**WOKINGHAM
BOROUGH COUNCIL**

Approval of Reserved Matters Consultation

Application Number: 251457

Site Address: Parcel 8, Finchwood Park, Sheerlands Road, Arborfield, Wokingham, RG40 4QY

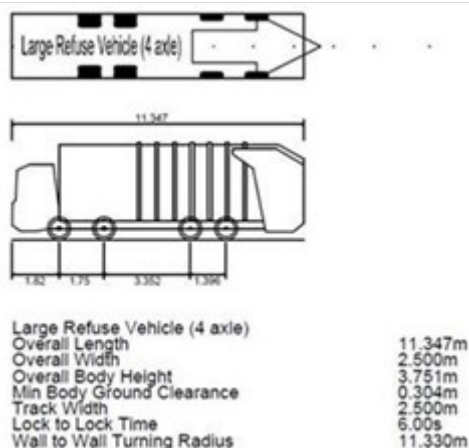
1. Drawing No. PLN-8-4005 (Rev. E) dated 28th February 2025 demonstrates visibility splays of 2.4m x 25m at internal site access junctions. This complies with the Manual for Streets visibility standard for the proposed 20mph speed limit. Corner radii of 4m and 6m are displayed for the access road north (hereafter 'A(N)') and south (hereafter 'A(S)'), respectively.

2. As A(N) provides access for 14 households, the minimum access road width is recommended to be 4.8m. As this road also provides access for refuse vehicle, the minimum width of the road should be no less than 5m.

- a) The revised site plan displays an access measuring 5.0m wide. This is now considered acceptable.
3. The LHA require visibility to be measured using a 2.4m setback from the give-way line for the site access. The visibility splay has been measured from 1.6m at the primary site access junction, as shown on Stuart Michael Associates Drawing No. PLN-8-4005-Rev-E titled 'Visibility Splays Parcel 8 dated Feb 2022'. Any landscaping within these splays will need to be maintained to a maximum height of 0.6m and therefore it is crucial the splay is correctly demonstrated in accordance with MfS requirements.

Distribution and Arrangement of Parking Spaces

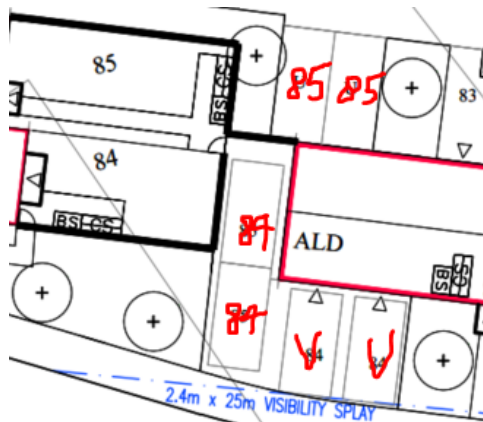
18. The proposed unallocated parking spaces are clustered around the flat blocks SB42, and similarly visitor parking spaces are clustered around the parking court opposite to Plots 70 and 71. The LHA recommend the visitor and unallocated spaces to be better distributed across the site.

19. The applicant shall explore the possibility for providing the parking spaces for Plot 75 on the same side of the dwelling.
20. To prevent additional parking that obstructs the turning head, it is recommended to reduce the driveway length for Plots 76-79, between the edge of carriageway and the garage, to no more than 13m.

21. If these garages for Plots 82 and 83 are not utilised for car parking, the LHA would recommend the applicant to convert the two unallocated parking adjacent to Plot 83 to visitor parking, and swap these parking spaces with Plots 84 and 85, as indicated below:

- a. **The LHA understand that the turning head cannot be amended without moving the garage and causing problems in deliverability and surface run-off/rainwater.**

- a. **The LHA understand the parking spaces cannot be relocated without locating the visitor spaces in front of the garages instead.**

- PLN-8-3000 (Rev. B) (Flat Block: SB32 Floor Plans and Elevations, dated 12.03.25).
 - BCS.01 (Rev. A) (Bin and Cycle Stores Floor Plans and Elevations, dated 19.03.25).

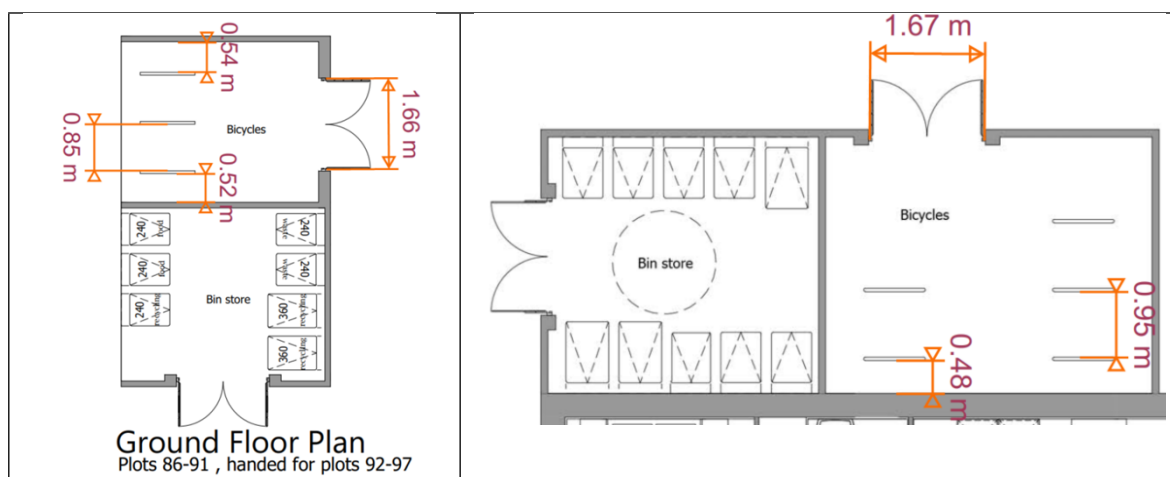
26. For the 21 flats proposed, there are 22 cycle parking spaces proposed with the following distribution:
- Plots 61 – 69: 10 spaces (5 Sheffield Stands) for 9 dwellings.

- Plots 86 – 91: 6 spaces (3 Sheffield Stands) for 6 dwellings.
 - Plots 92 – 97: 6 spaces (3 Sheffield Stands) for 6 dwellings.
27. According to Table 11-2 of LTN 1/20, the LHA recommend increasing the spacing of between stands to 1.2m (recommended) or 1m (minimum), and increasing to gap between stand and wall to 0.7m (recommended) or 0.5m (minimum), which may require to increase the dimensions of the proposed communal cycle stores as shown in the following Drawings:

a. Points 23 – 27: The LHA accept the revised cycle store drawings. The revised site plan shows cycle storage with correct spacing between stands and this cycle storage is now accepted.
